**R66 SERVICE BULLETIN SB-41C**  
(supersedes R66 Service Bulletin SB-41B)

**DATE:** 22 December 2022      **REV C:** 28 January 2025

**SUBJECT:** Tail Rotor Blade Inspection and Replacement

**EFFECTIVITY:** P/N F029-1 tail rotor blade S/Ns 3099 and prior (F029-1 REV F and prior).

**SPECIAL TAIL ROTOR TIP PREFLIGHT INSPECTION**

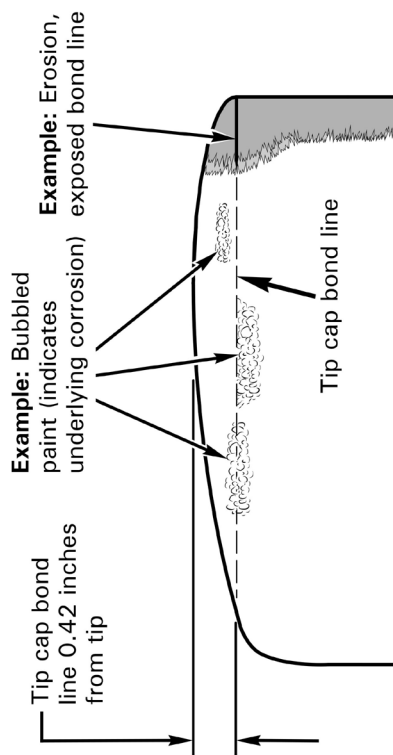
To be performed before the first flight of each day. May be performed by pilot or mechanic. Conduct visual inspection of tail rotor tip area. If bubbled paint or other evidence of corrosion is observed at or adjacent to tip cap bond line or if any portion of tip cap bond line is exposed, do not fly helicopter. Comply with latest revision of R66 SL-40 prior to further flight.
